**Our Case Number: ABP-313892-22**

**Re: Bus Connects Blanchardstown to City Centre Core Bus Corridor Scheme  
Blanchardstown to Dublin City Centre**

**Re: Bus Connects Blanchardstown to City Centre – ref ABP-313892-22**

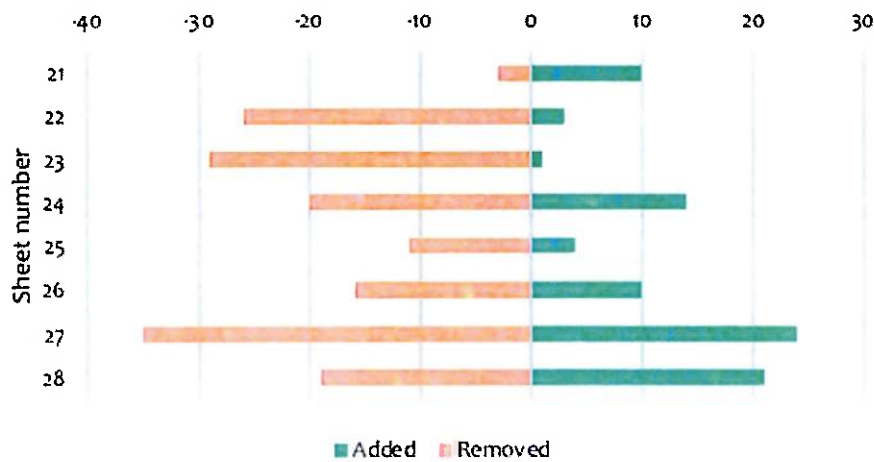
Again, I welcome that overall there will be an increase in trees along the BusConnects route. However, the NTA choice of the stretch of road for which statistics were provided in its response to highlight tree planting from Parkway station downplays the extent of tree removal along footpaths on the Navan Road between the Halfway House and Old Cabra Road. About 60% of the 230 trees mentioned in the NTAs response are proposed to be planted between Navan Road Parkway and the current Ashtown Roundabout (sheets 18-21<sup>8</sup>) or are not directly along the footpath where existing trees will be removed. Within the current proposals, the 2.5km segment of the Navan Road between the Halfway House and Old Cabra Road will have a significant amount of tree removal, with limited replacement trees (sheets 22 to 27).

This part of the BusConnects route is expected to have 38.5% of tree removal for the whole scheme but only 11% of replacement tree planting<sup>9</sup>. The issue is particularly severe for the south side of the Navan Road where I estimate 84 trees are planned to be removed but only 20 replaced (a 76% reduction), with replanting concentrated outside the Belvedere sports grounds and outside the Eir premises near Hampton Green. *See annex 2 for a summary of the relevant maps.*

The significant impact of the loss of trees has been recognised by the NTA in relation to sheet 23/23 at least (see above regarding figure 2.2.23), however, no additional efforts to mitigate the impact have been proposed.

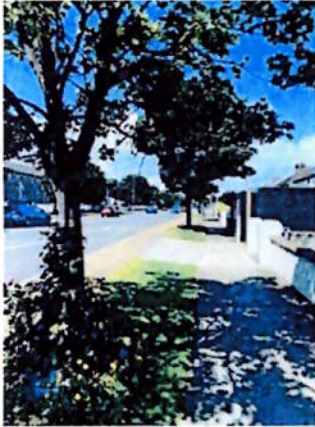
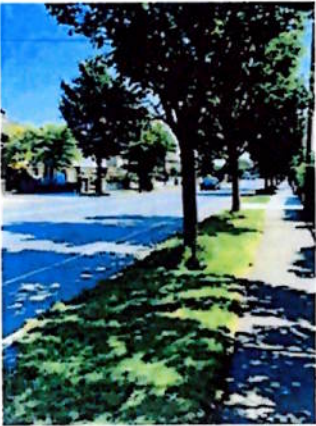
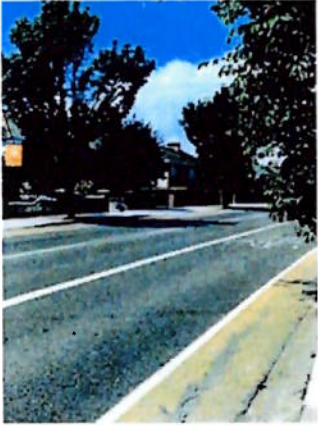
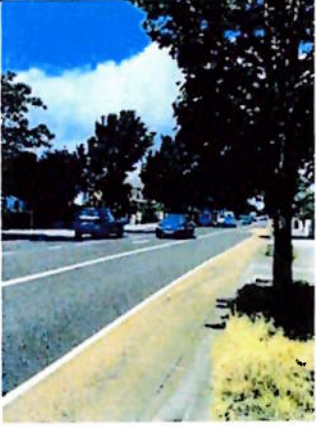
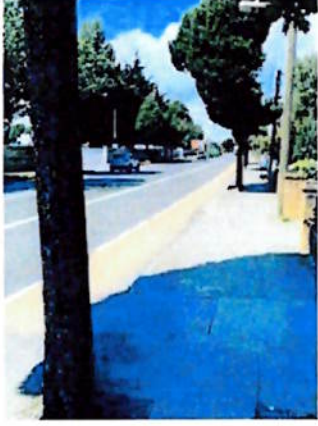
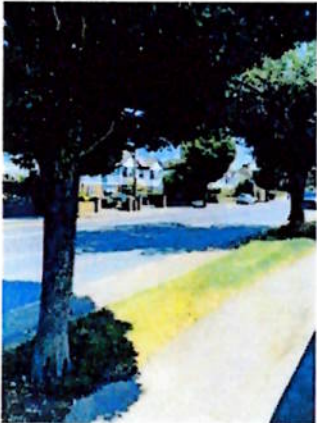
The following stretches of road, under the current plan, would have a significant change in their character and would appear to be completely mis-aligned with stated policy objectives under DMURS in relation to street trees. If implemented as planned, it is likely that people along the route would be more likely to use their cars rather than walk or cycle and would lose the positive impacts in terms of air quality, shade, mental wellbeing and safety when using the road:

- Kempton entrance to Kinvara Ave/Baggot Rd junction, in particular the South side of the road where there is no new replacement tree planting
- Garda station to Tesco, on the South side, bar planting away from the path near the entrance to Hampton Green
- Parts of the North side of the road between Kinvara Ave junction and 157 Navan Rd

Sheet	Read left to right	
23 / 24	<p data-bbox="531 293 655 324">South side</p> 	<p data-bbox="919 293 1267 324">South viewed from North side</p> 
24	<p data-bbox="536 853 660 884">North side</p> 	
		Both sides

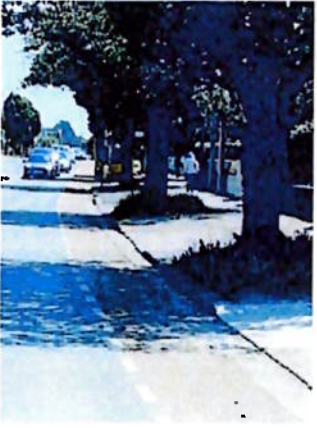
As an alternative to the photomontages presented by the NTA, photos of current trees along segments of the Navan Road are provided below. All of these trees are proposed to be removed with most not replaced. These pictures also demonstrate the benefits of the trees in terms of:

- Shade
- Barrier to the road
- Visual amenity

### ***Directional signage approaching the junction of Navan, Ashtown and Castleknock Roads***

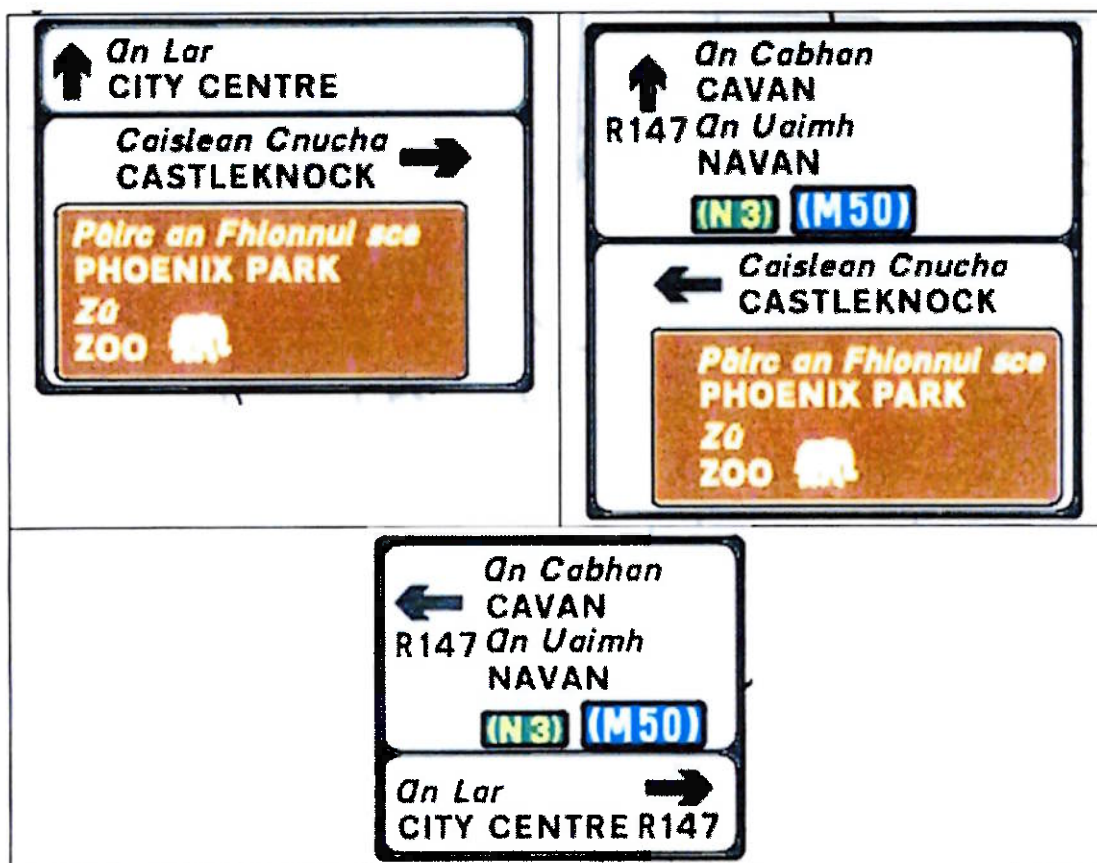
I note that directional signage approaching the junction of Navan Road, Ashtown Road and Castleknock Road does not make reference to the areas of Rathborne and Royal Canal Park which are accessible via Ashtown Road<sup>11</sup>. With a population of close on 6,000, which will rise above this based on current planning permissions, it is important that Rathborne and Royal Canal

Park are included on relevant signage. It may also be relevant to include Ashtown train station on these signs<sup>12</sup>.

No rationale has been given by the NTA for their refusal to include Rathborne and Royal Canal Park on relevant signage.

4. That signs approaching the junction of the Navan Road and Castleknock Road at Ashtown (as per drawing BCIDC-ARP-TSM\_GA-0005\_XX\_00-DR-CR-0021<sup>3</sup>) from the west, east and south include directions to the areas of Rathborne and Royal Canal Park which are situated to the North of the Navan Road at that junction.
